## LINCOLN PARK PLANNING COMMISSION

## 1519 Southfield – Taco Bell

### Site Plan Review

Applicant	Matt Yanda, GDP Group
Project	Taco Bell
Address	1519 Southfield Road, Lincoln Park, MI 48146
Date	December 9, 2020
Request	Site Plan Review
Recommendation	Approve with Conditions

MASONRY  
FENCE WALL  
DETAIL

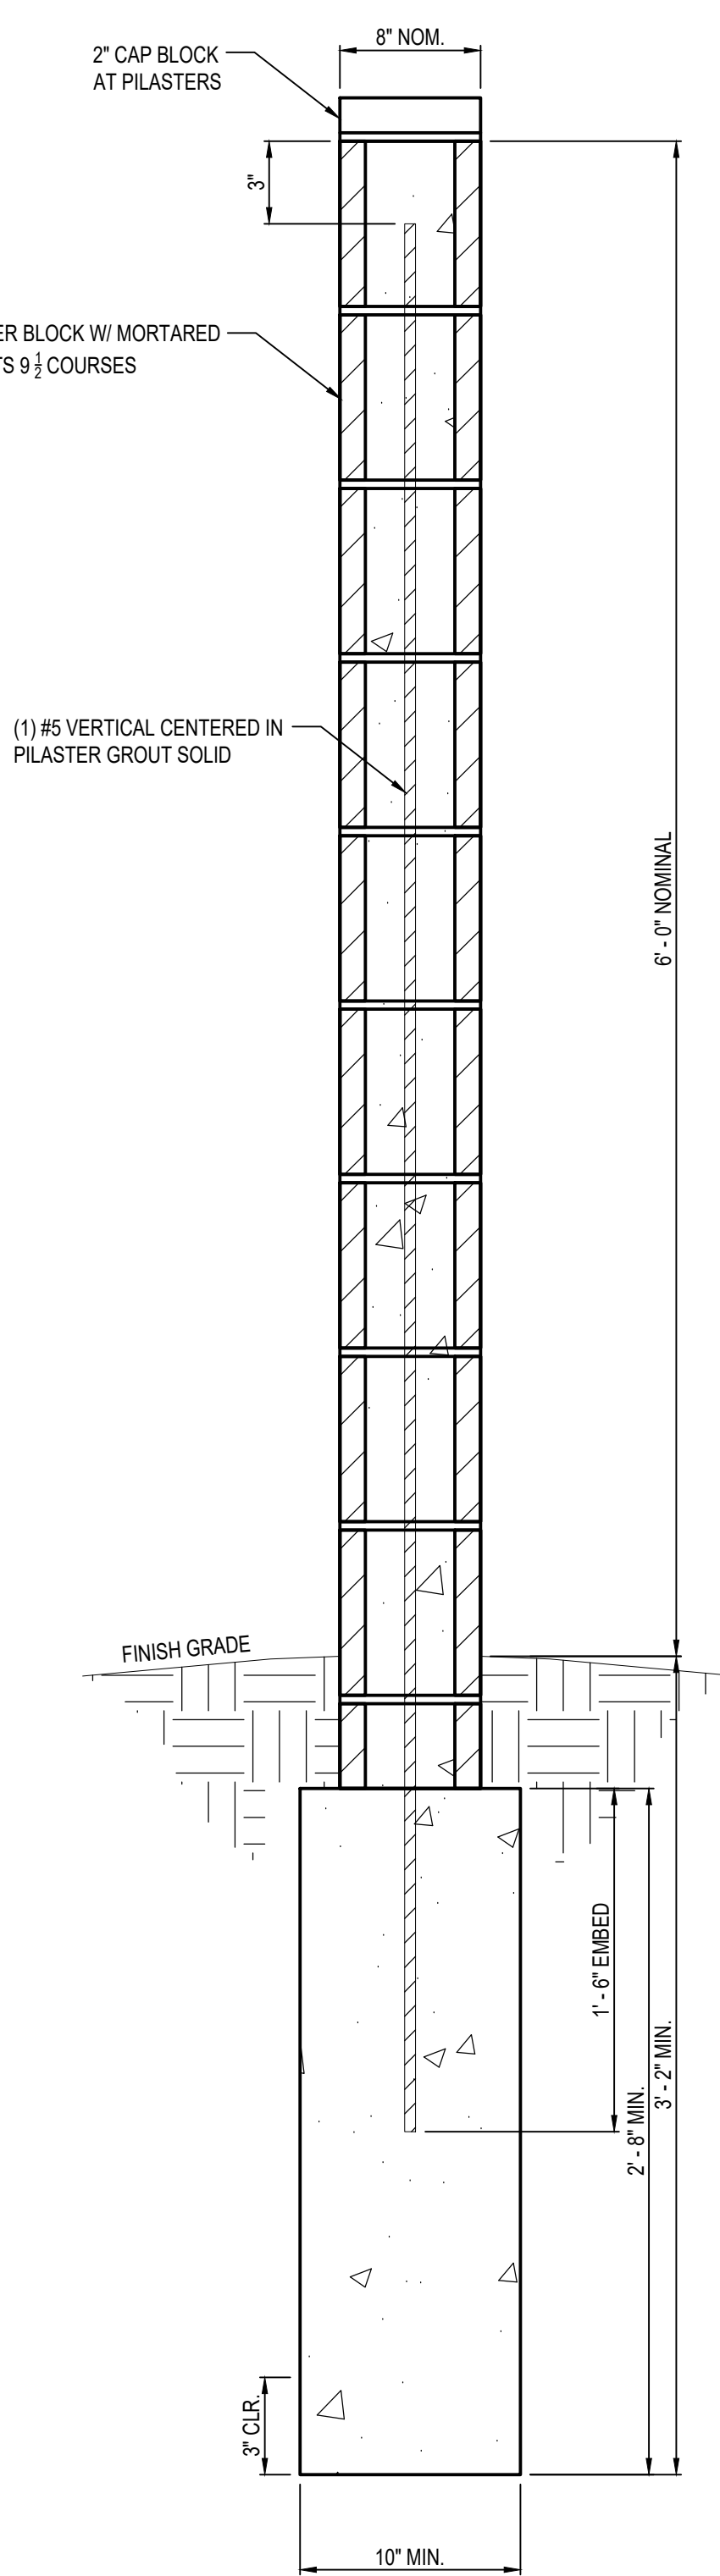
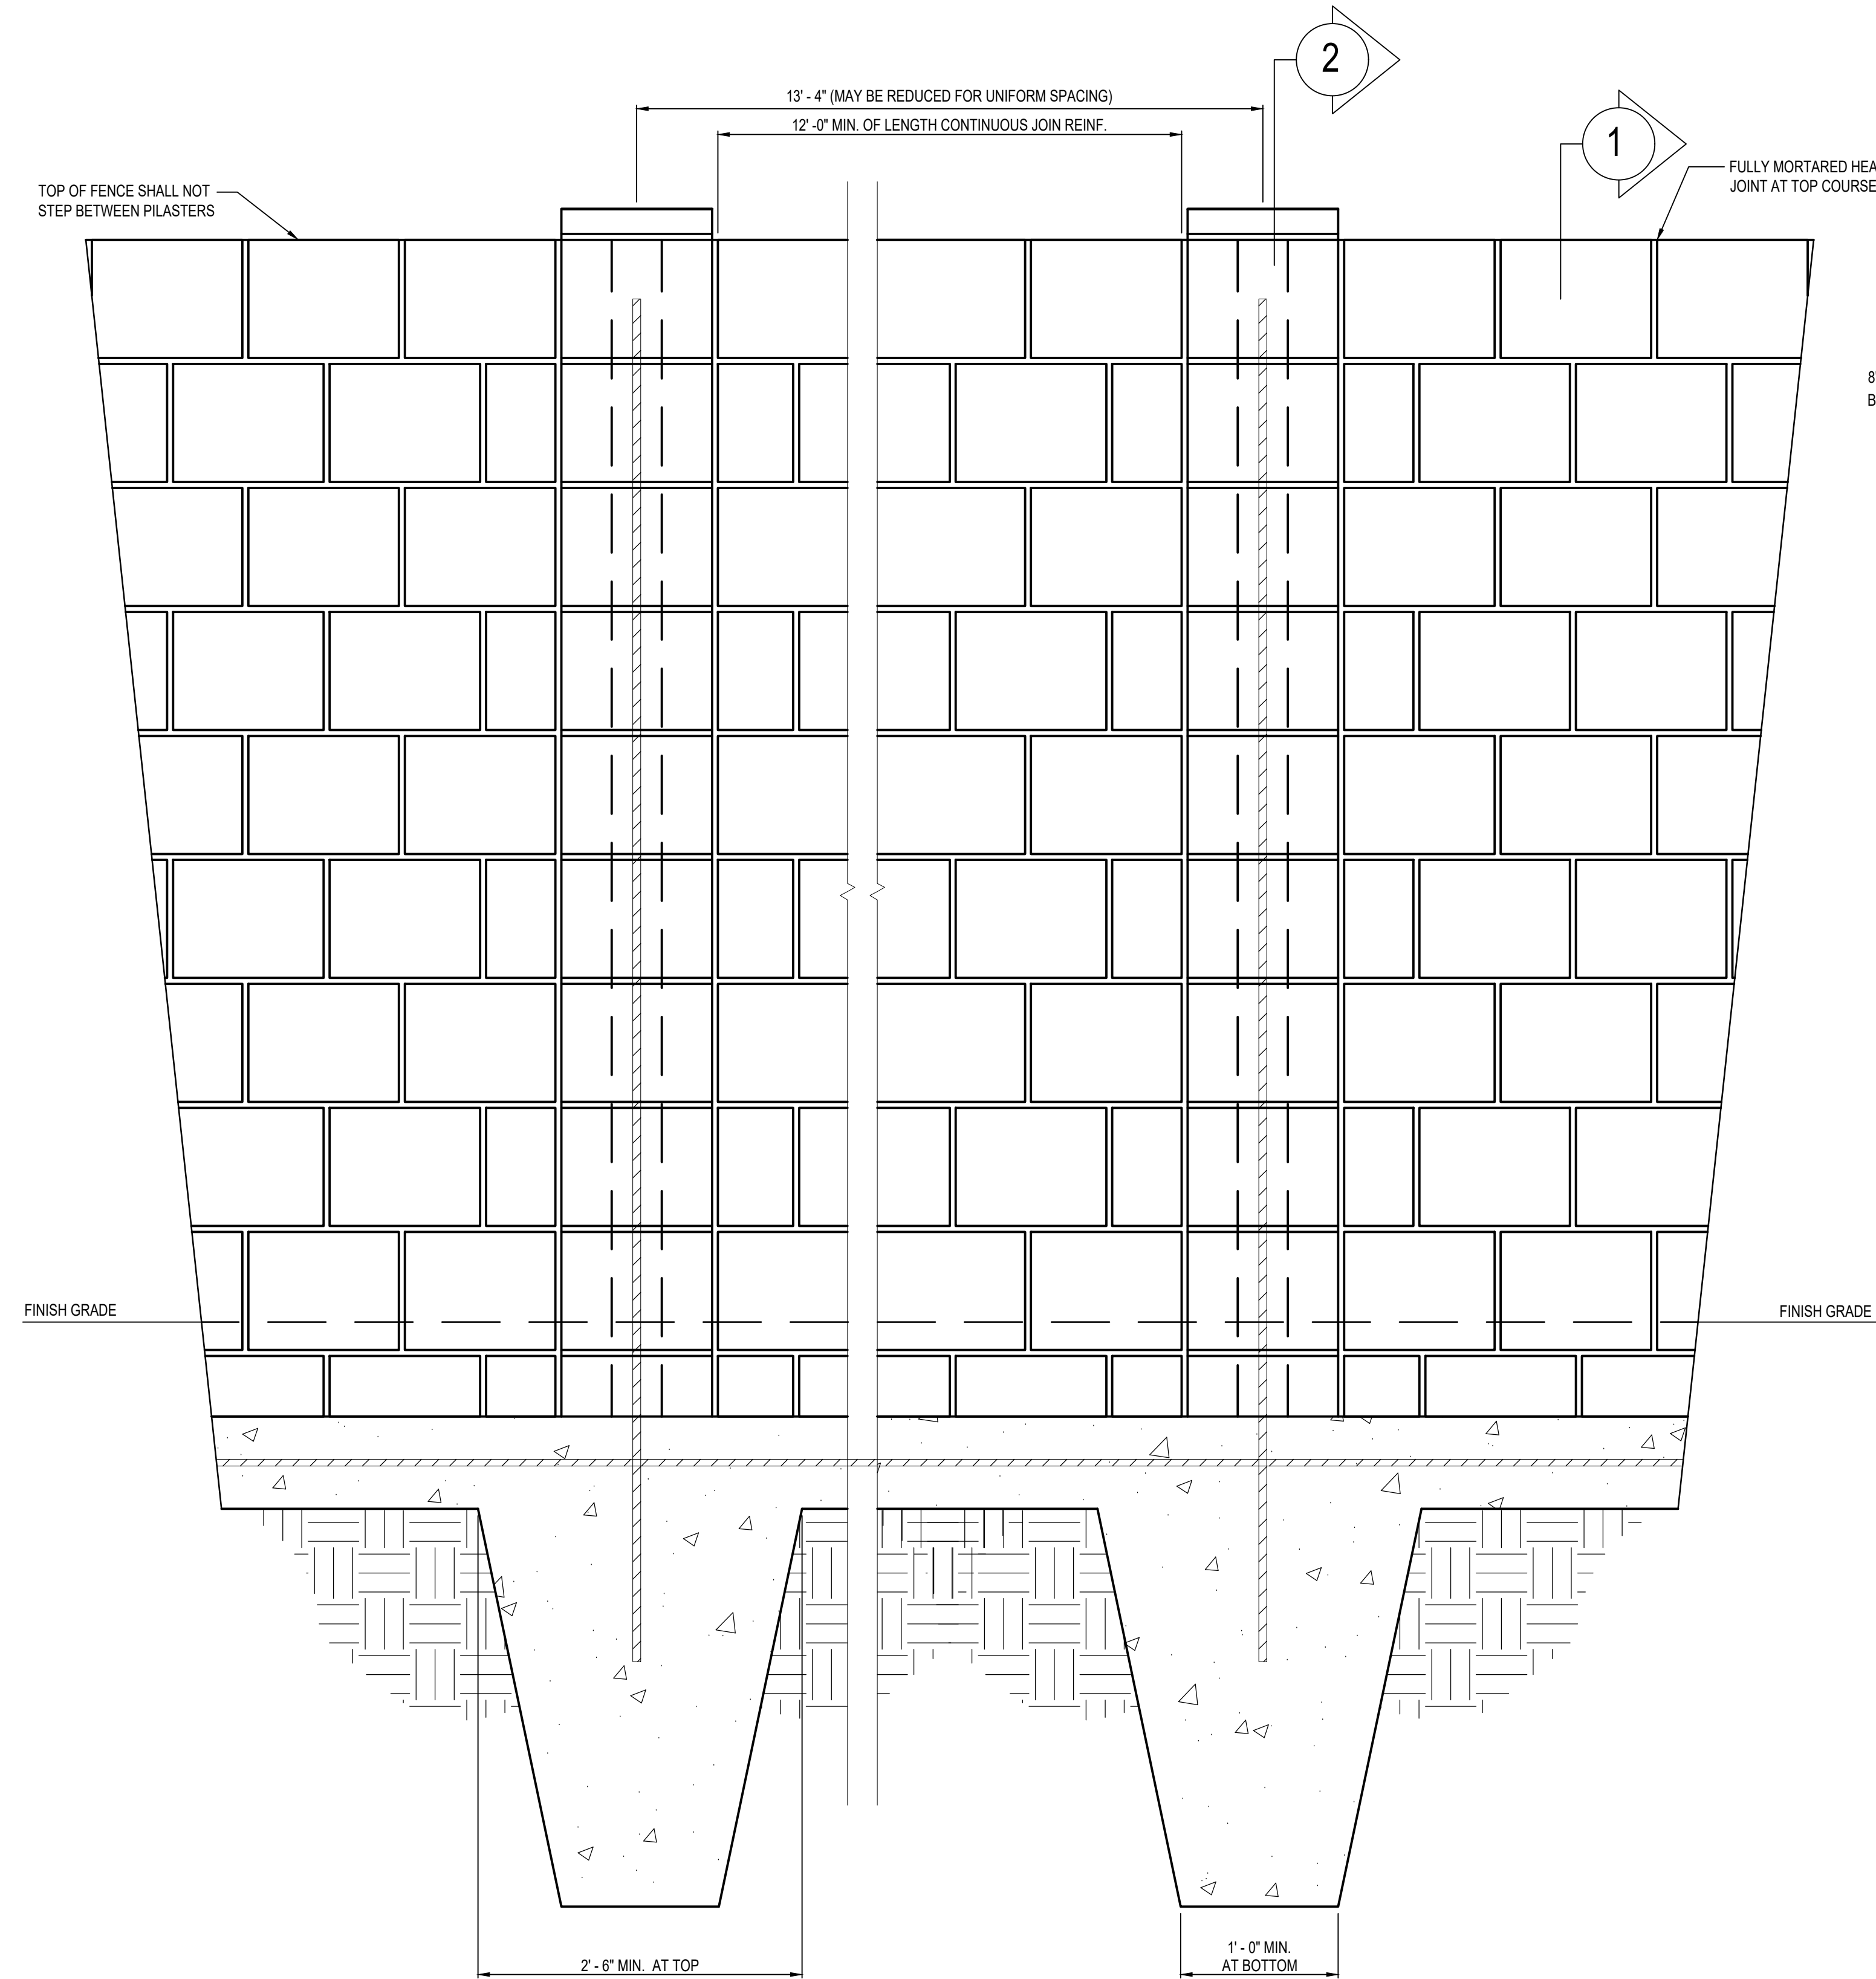
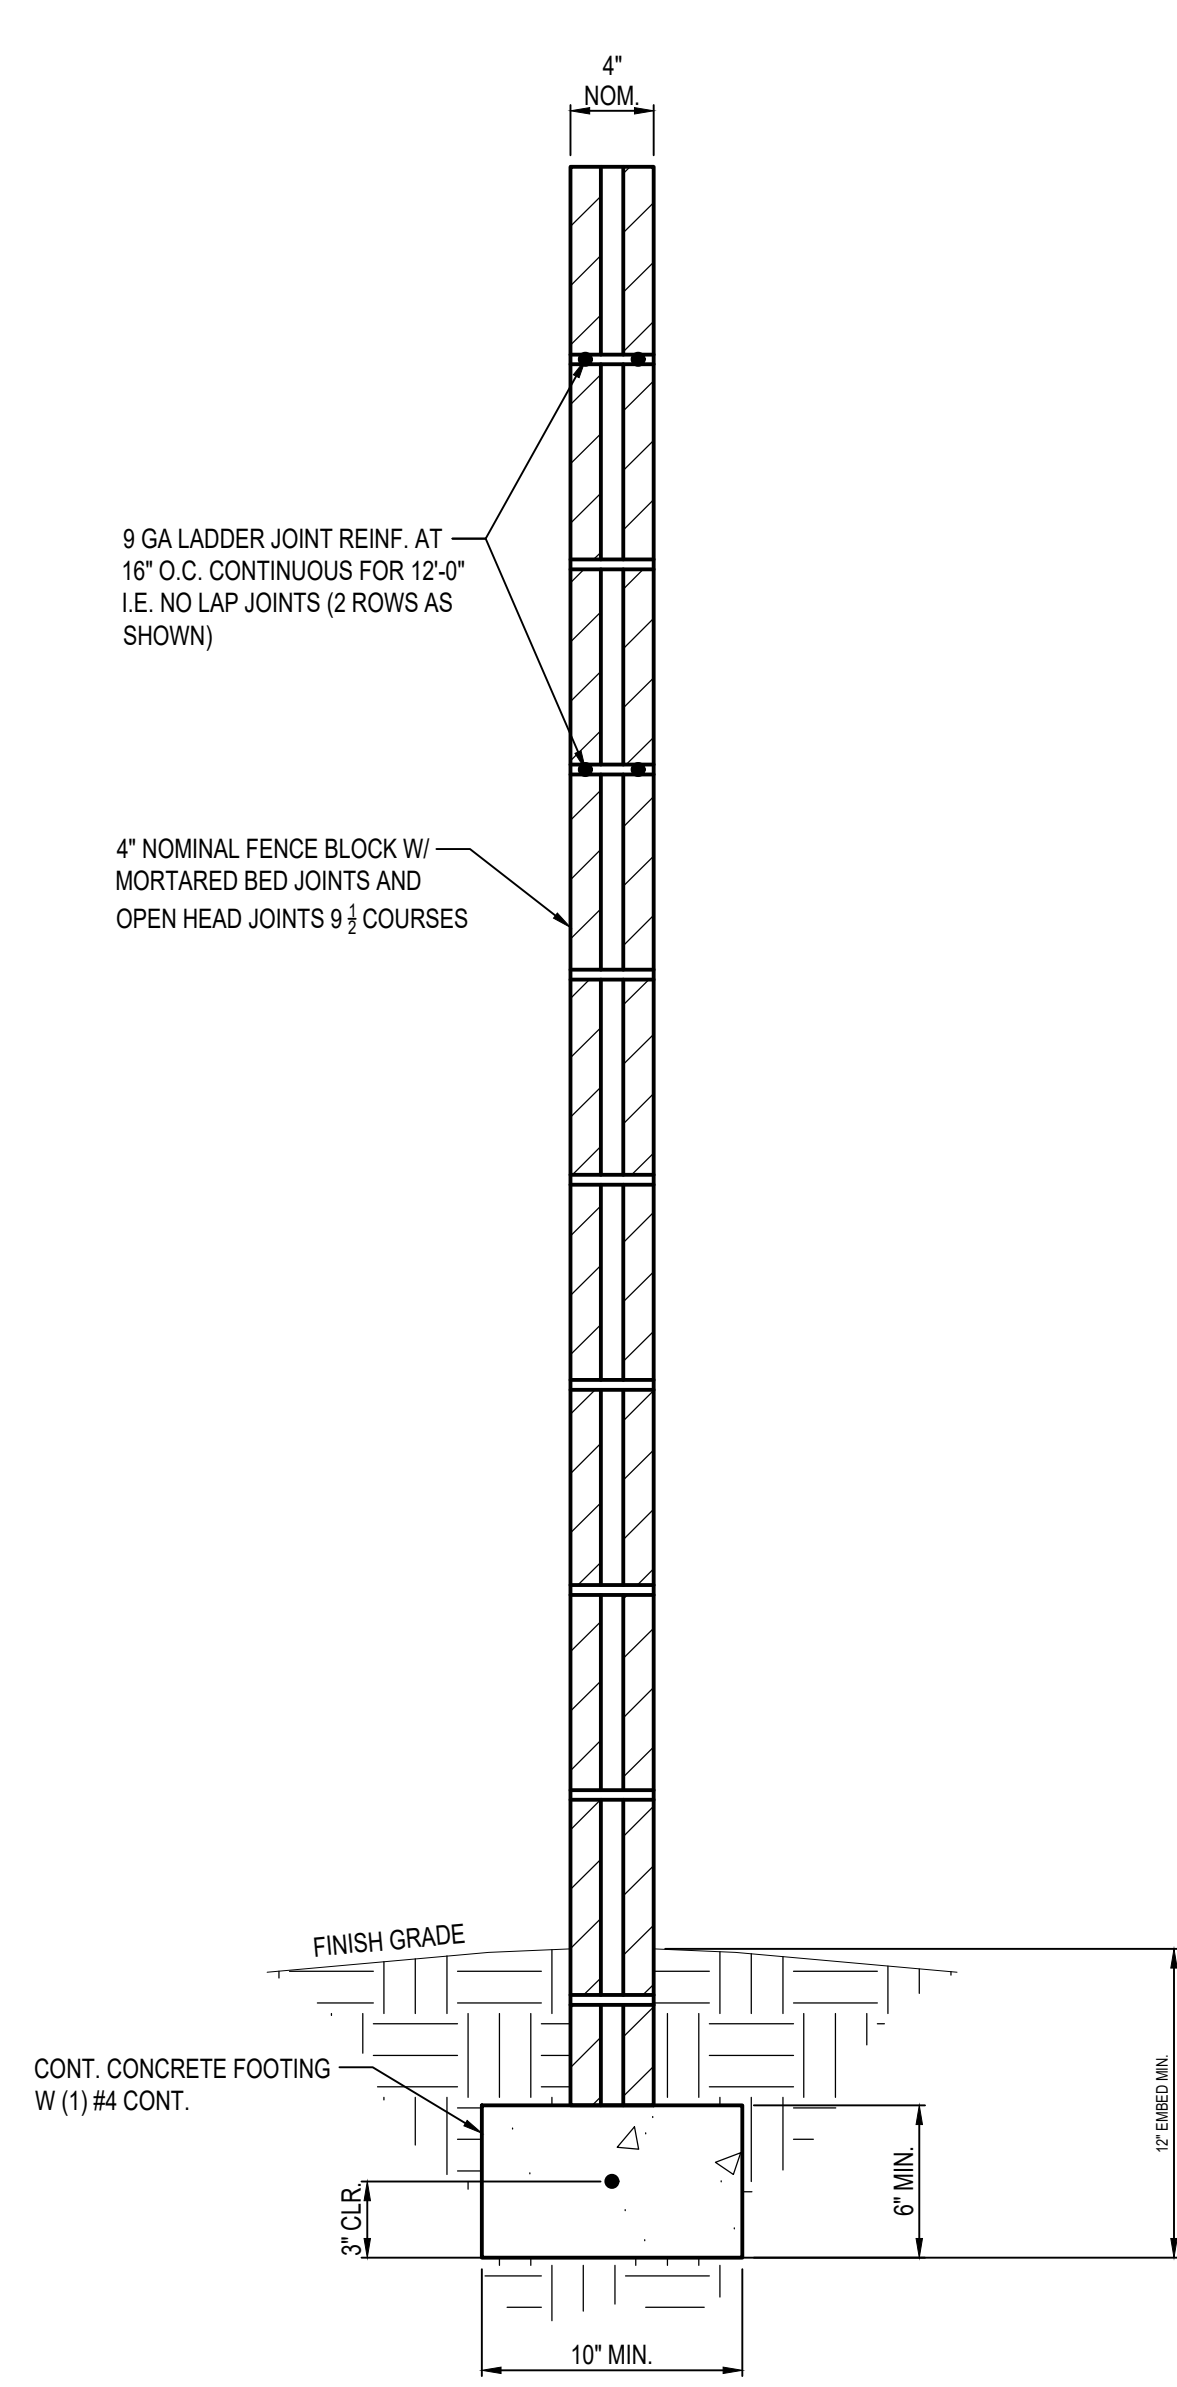
- Applicant shall provide color details for the proposed masonry wall to ensure it is consistent with the principal building.
- Applicant shall provide manufacturer specifications and measurements in footcandles to ensure that lighting is arranged to deflect away from adjacent properties and so that it does not impede the vision of traffic along adjacent streets.
- Applicant shall address emergency vehicle access to the drive-thru lanes.
